CHANGE REQUEST		Please see embedded help file at the bottom of this page for instructions on how to fill in this form correctly.	
24.008 CR xxx		Current Version: 3.3.1	
GSM (AA.BB) or 3G (AA.BBB) specification number ↑		↑ CR number as allocated by MCC support team	
For submission to: TSG CN#8 <small>list expected approval meeting # here ↑</small>	For approval for information	<input checked="" type="checkbox"/>	strategic <input type="checkbox"/> non-strategic <input type="checkbox"/> <small>(for SMG use only)</small>

Source: Ericsson **Date:** 2000-06-18

Subject: Removal of Service Accept message

Figure 46: Service Request Initiated by MS Procedure

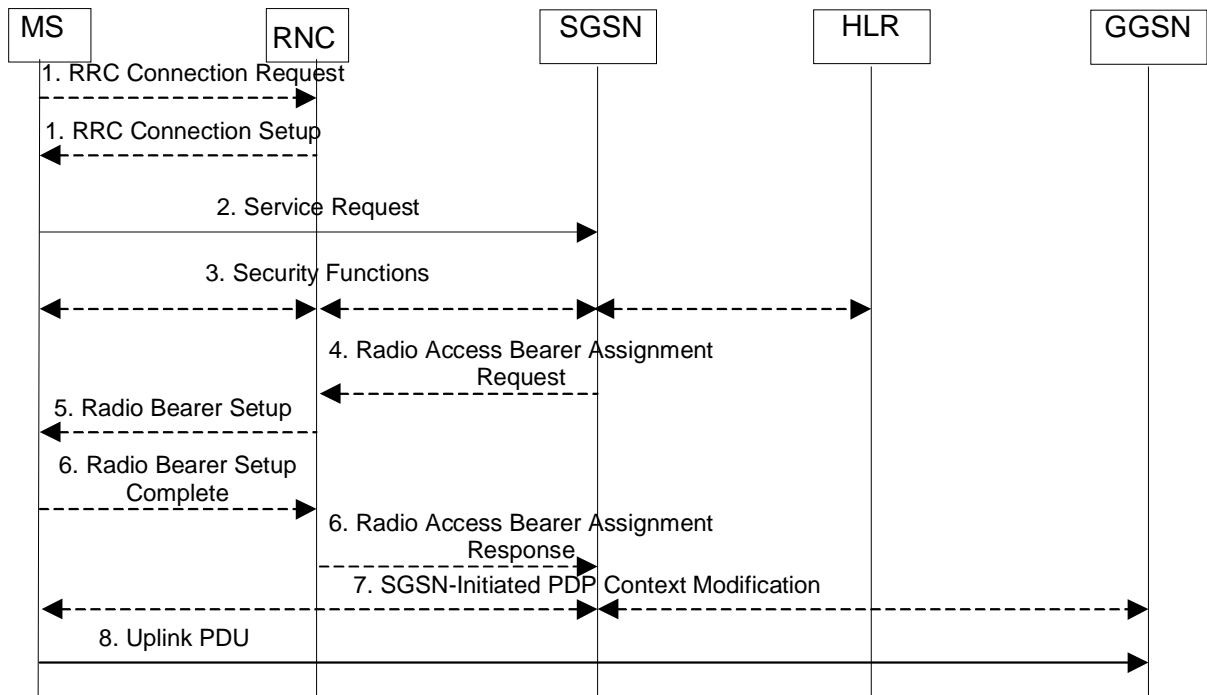
Reason for change: This CR proposes to remove the Service Accept message, as it is not needed. This has already been agreed in S2 (see attached annex A from TS 23.060).

For Service Type = Signalling, the MS knows that the Service Request message was successfully received in the SGSN when the MS receives the RRC Security Mode Control Command message.

For Service Type = Data, the MS knows that the Service Request was successfully received when the MS receives the Radio Bearer Setup message from the RNC.

For any Service Type, in case the service request cannot be accepted, the network returns a Service Reject message to the MS with an appropriate cause value.
